Fassaugh Avenue, Cabra

Proposed Build to Rent Mixed Use Development
Strategic Housing Development Application

APPENDIX: RESPONSE TO ABP AND DCC OPINION

JANUARY 2022

LEVEL 00

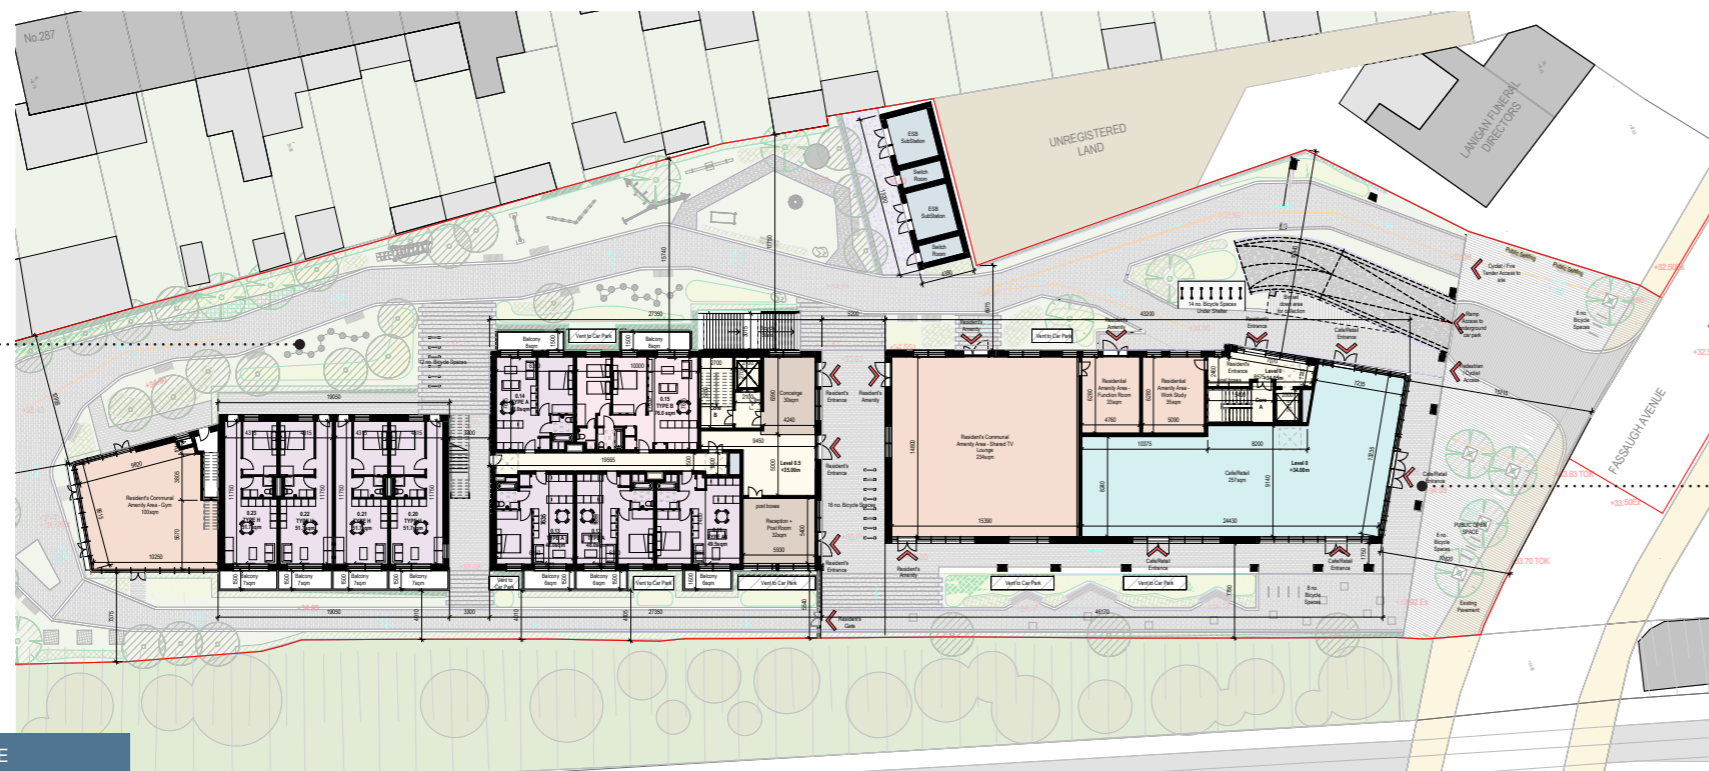
A total of 15% of the GFA has been removed from the building, including a 1-2 level reduction in height, and significant reduction in scale and massing to the northern end of the building. At this northern end, the north-east corner of the building has been set back to maintain a minimum 11m setback from the boundary to St Attracta Road properties, reducing the potential for overlooking and impact of the scheme on its context, with screened balconies offering further reductions.

Significant reduction in scale and massing to northern end, to decrease impact on St Attracta Road properties

At ground level, the building footprint has been reduced by 383sqm, representing a 22% reduction from pre-app. This reduction has been concentrated in two locations so as to reduce the scheme's scale and massing.

To Fassaugh Avenue, the footprint on ground level has been set back by 2700mm to increase the quantum of public open space. To the north east, the building has been considerably set back by circa 5m to maintain a minimum 11m distance from the site boundary to St Attracta Road properties. The scheme has also been broken into three distinct blocks on this floor: a commercial/amenity block towards Fassaugh Avenue, a render-clad residential block to the middle, and a brick-clad townhouse block to the north.

B OPEN SPACE STRATEGY

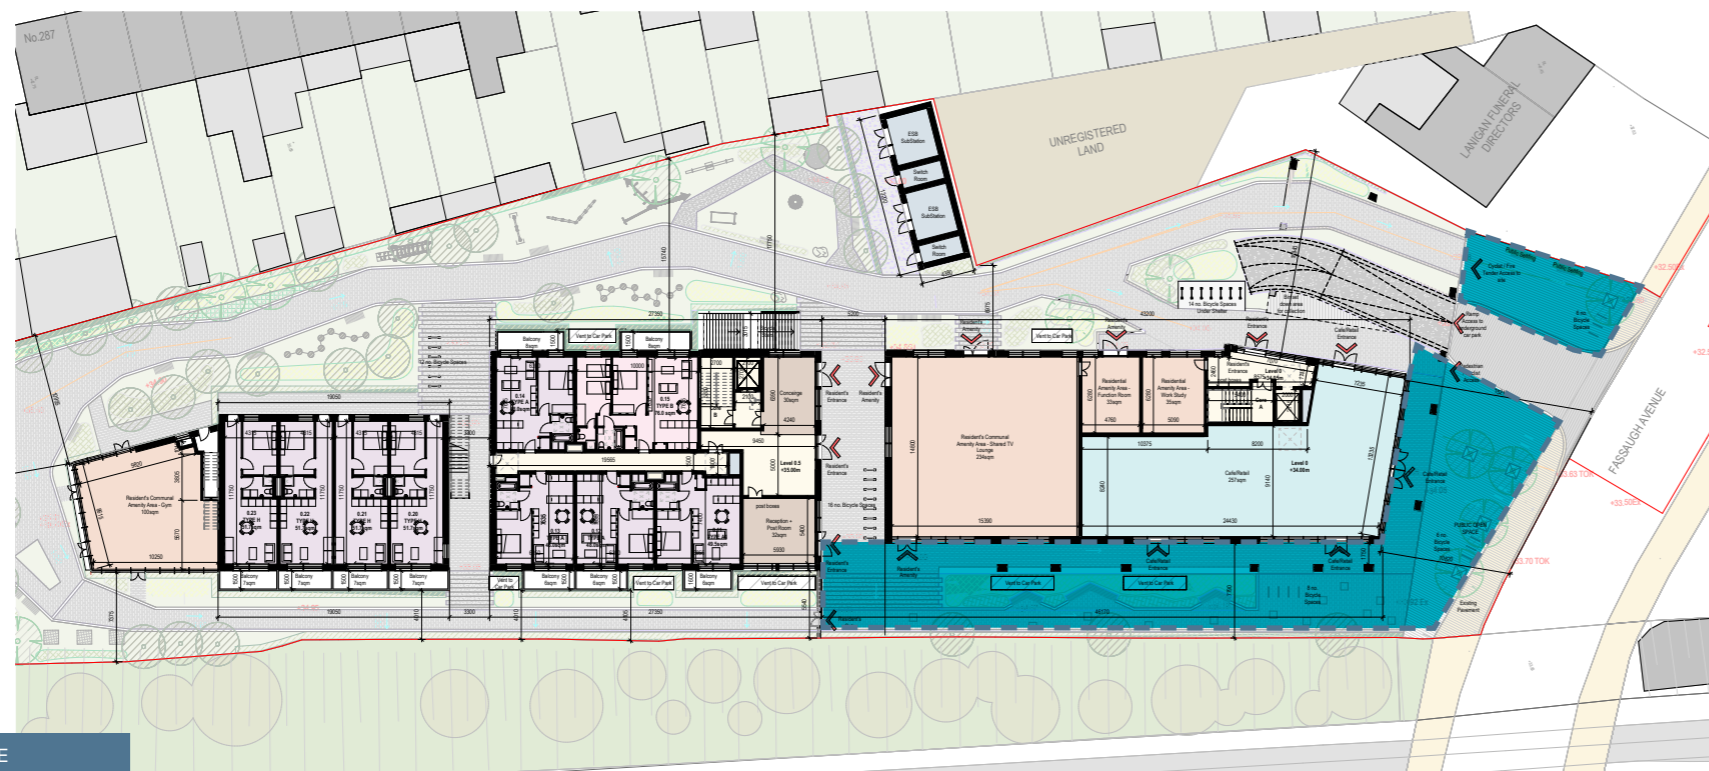
Open space strategy.

The proposed scheme increases the quantum of public open space from 372sqm to 582sqm, representing an increase of 56%. The proposal therefore allocates 10% of the site area to public open space.

This increase has been achieved through a reduction in the building footprint to the south and west on ground floor, creating high-quality public realm adjacent to the ground floor commercial unit. This space's usability has been enhanced through the incorporation of bicycle parking, planting, and seating. Please refer to the Landscape Vision report prepared by BDP for further details on the proposed open space strategy.

EAST ELEVATION - PRE-APP SCHEME

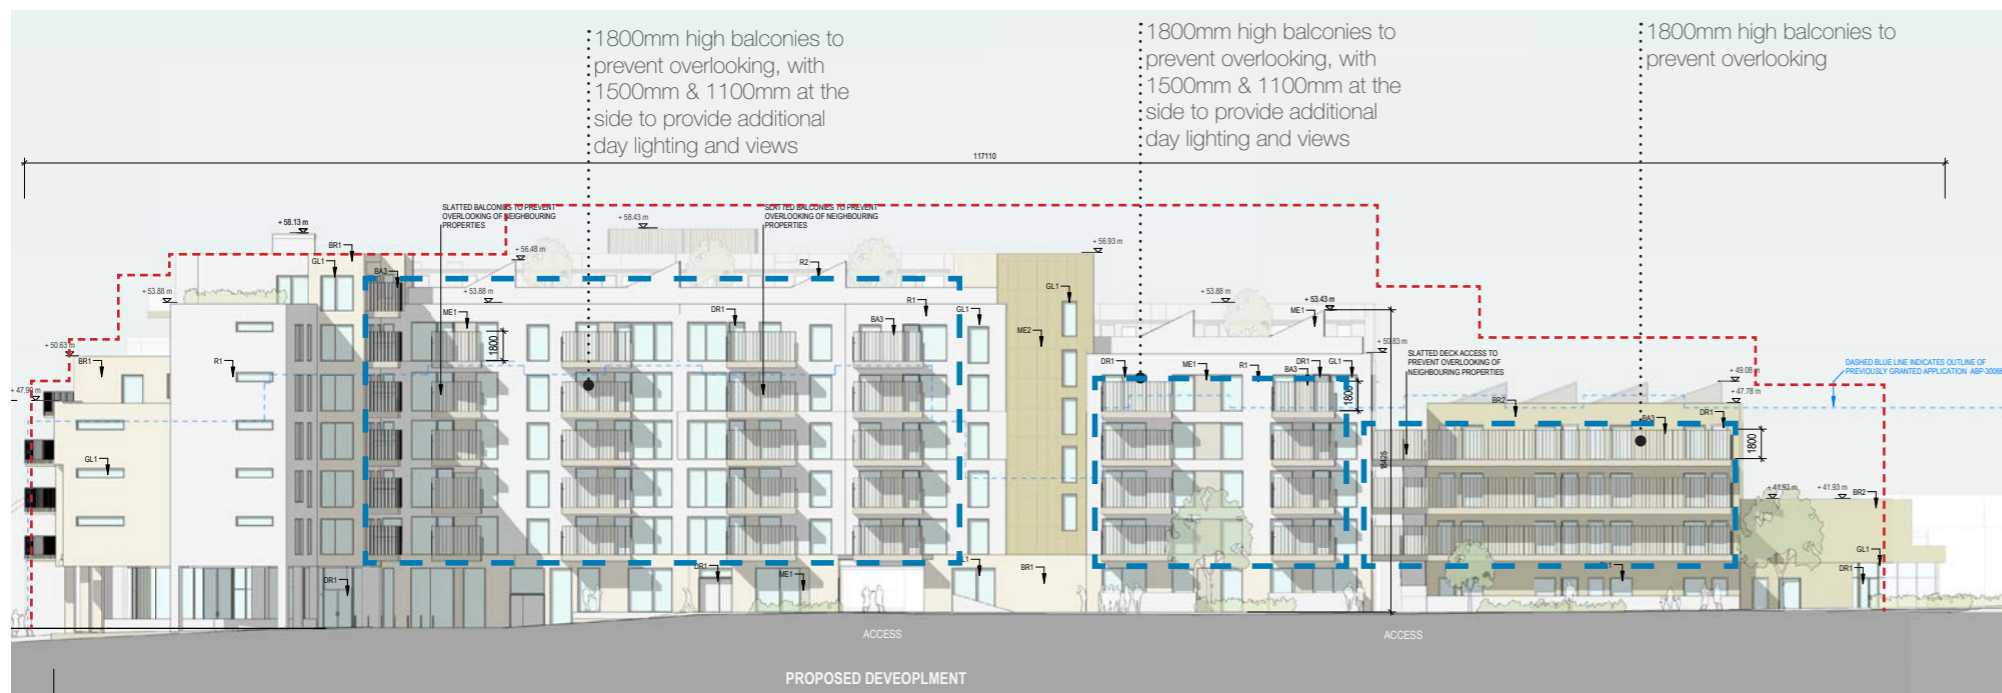
DCC: Render, coloured metal and steel does not compliment surrounding brick neighbourhood

DCC: Roof level requires greater architectural refinement

Response: Coloured metal treatment to balconies has been significantly reduced, while the use of brick across the scheme has been increased, particularly on elevations visible from Fassaugh Avenue.

Response: The roof profiles across the scheme has been simplified with fewer changes in parapet height. To further refine the roof profile, a detached block to the north features pitched skylight profiles reflecting the pitches incorporated along the east elevation. These pitches to the east elevation have been stepped back from the parapet in order to simplify the roof

Additional communal amenity space, allocated as a gym
Soft planting surrounding private amenity

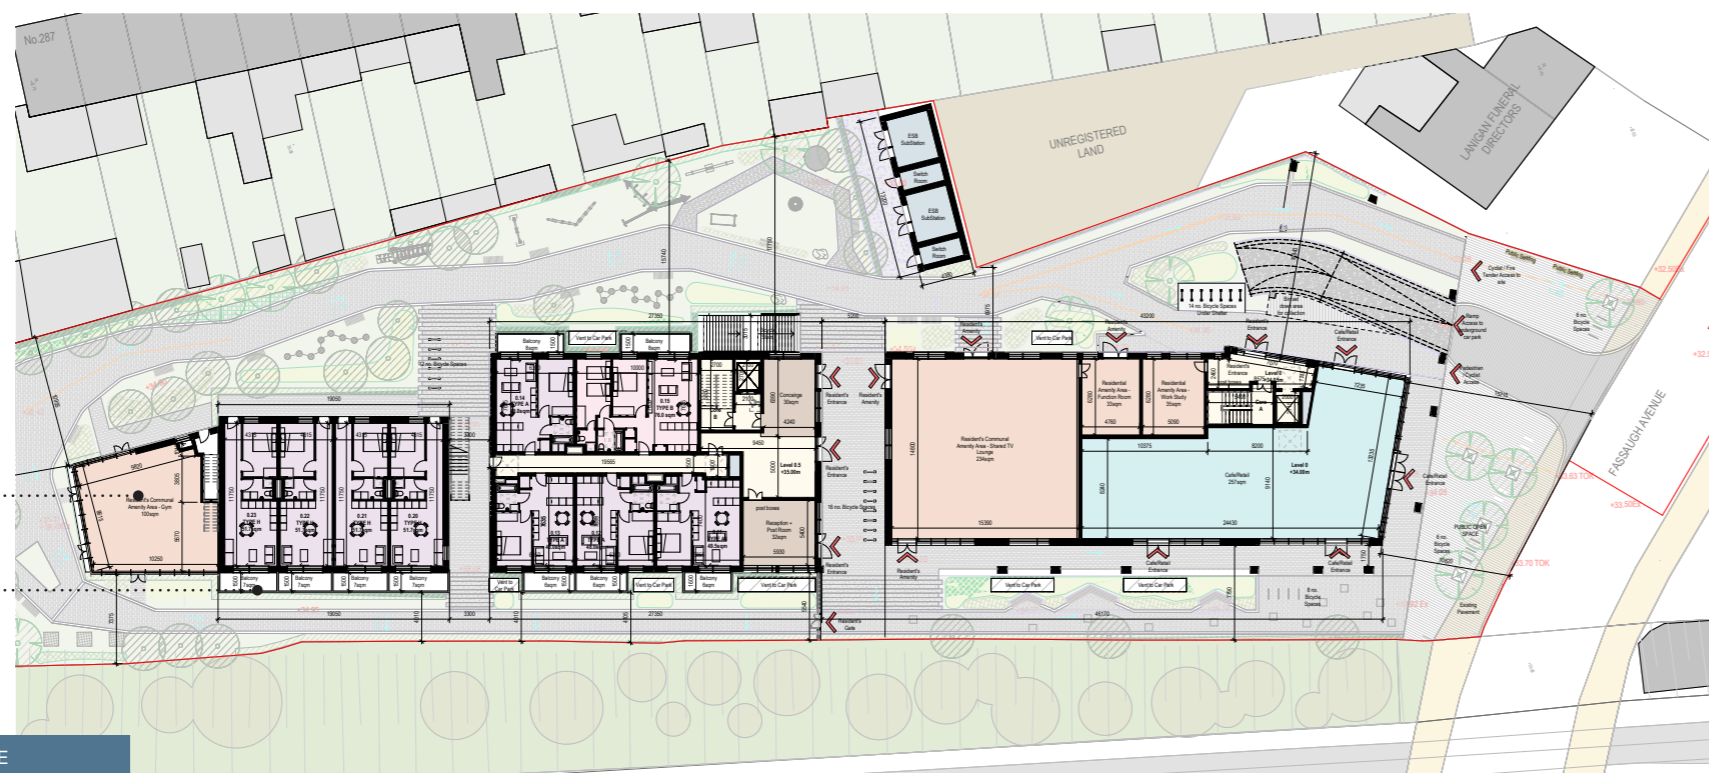
DCC: Gym does not appear feasible to operate given size and amount of doors

DCC: Layout of public open space gives rise to serious conflict between vehicles, pedestrians, cyclists

Response: The gym, previously located in the basement, has been relocated to the ground floor communal space on the northern end of the building and opens out onto the communal open space. The number of doors has reduced and the shape has been regularised for ease of use. The size of the space has increased from 62sqm to 100sqm.

Response: The public open space allocation has been revised to exclude any area of vehicular movement. Vehicles will now enter the site to perform turning manoeuvres, as set out in the attached transport strategy. Private vehicles proceed directly to the basement car parking.

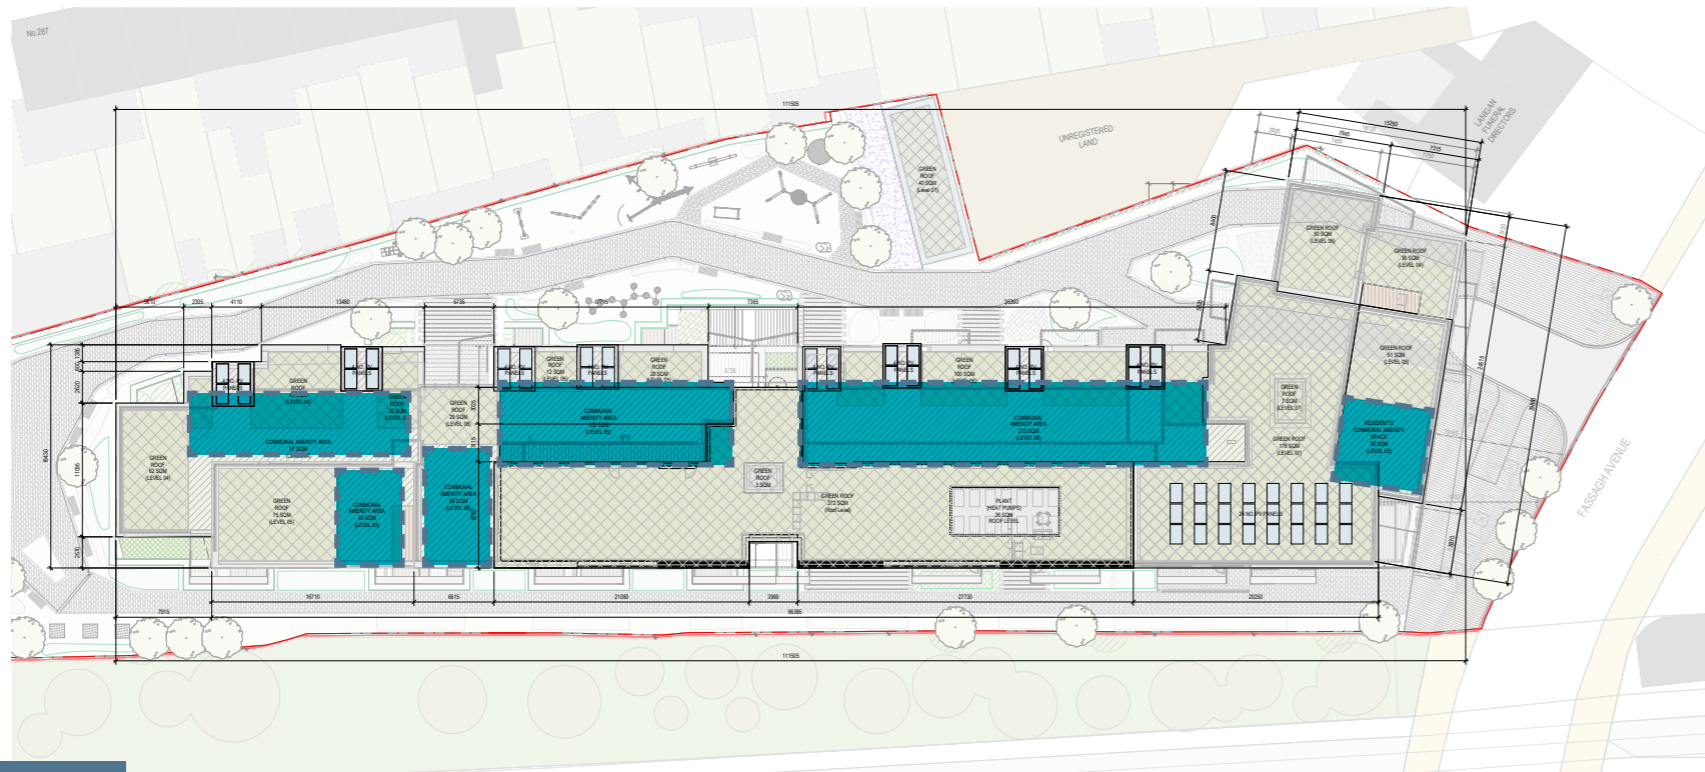
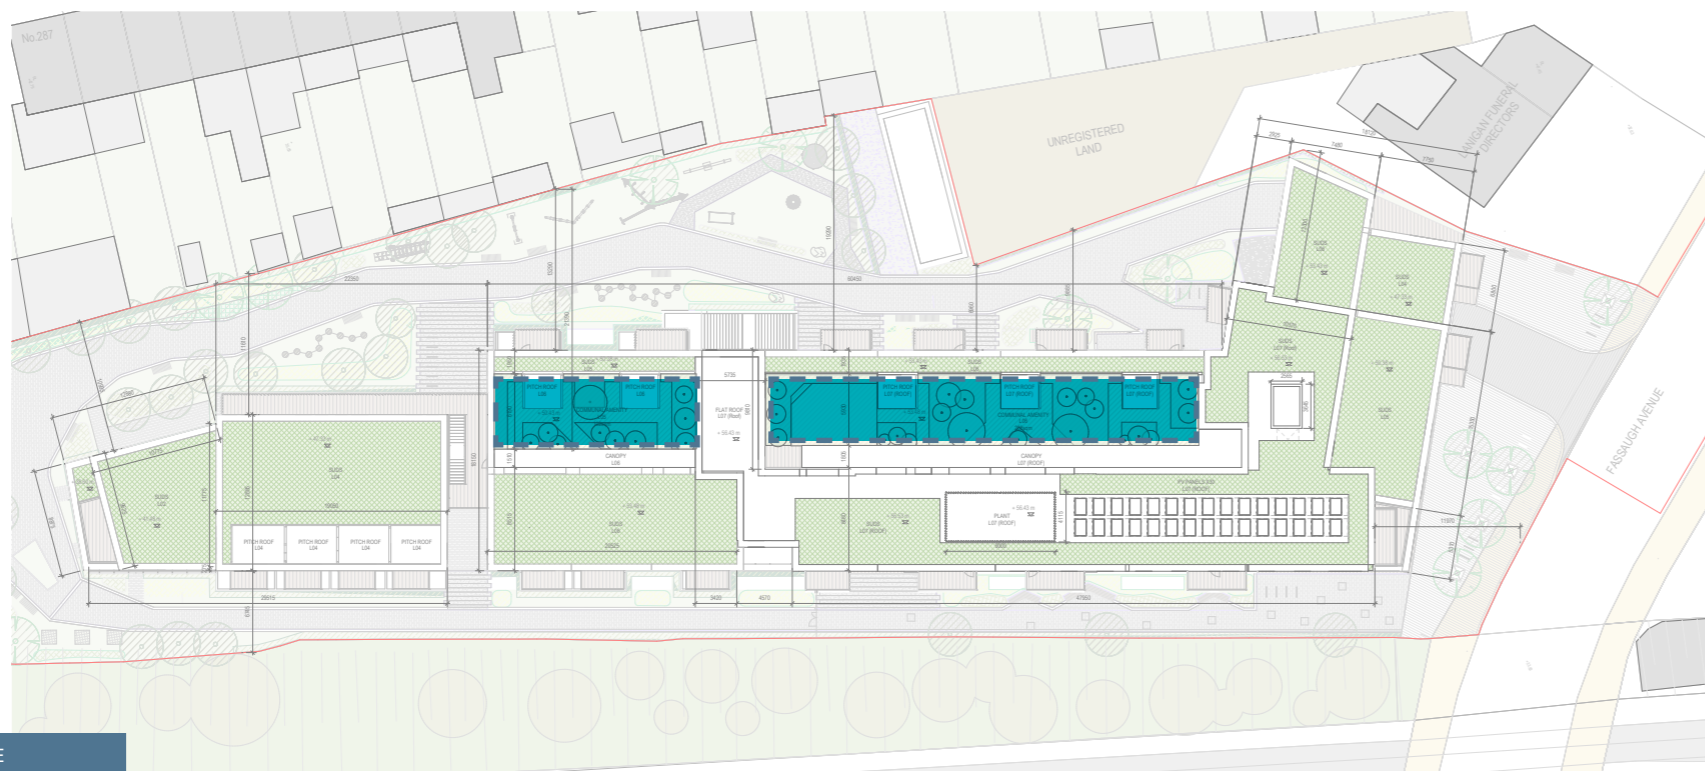
Further consideration and/or justification of the documents as they relate to residential amenity, having particular regard to the potential for overlooking, overshadowing, and overbearing impacts on existing adjoining residential properties and proposed residential units within the scheme. The response should include a detailed Sunlight, Daylight and Shadow Assessment of inter alia units proposed, communal open spaces, public open spaces, and adjoining lands an properties.

The scheme has been revised from pre-app stage in order to reduce the potential for overlooking, overshadowing, and overbearing impacts on residential properties adjacent to and within the development. The proposed scheme has been reduced by 1-2 storeys, and set back a minimum of 11m from the boundary with St. Attracta Road properties, to improve the VSC and overshadowing impacts. These improvements are set out in reports accompanying this submission, including the Daylight report prepared by BDP.

Private amenity balconies on the east elevation that face St Attracta Road which were 1500mm high at pre-app stage have been increased to 1800mm in order to ensure said balconies do not create overlooking issues onto St Attracta Road rear gardens. These balconies have been designed with slatted screens to ensure outlook from the resident private amenity is not compromised, and are views directed away from the St Attracta gardens.

The quantum of communal open space at roof levels has been significantly reduced from 568sqm to 310sqm. The two communal open space spaces at roof levels which have been retained have both been treated with a parapet screening to prevent overlooking, including a setback of 1.95m from the parapet edge.

Communal open space at roof level to the northern area of the building has been removed, due to its proximity to St Attracta Road.

Private amenity balconies overlooking Lanigans Funeral Home have been removed in order to prevent overlooking, facilitate future development, and increase the boundary distance of the proposed development to the neighbouring property.
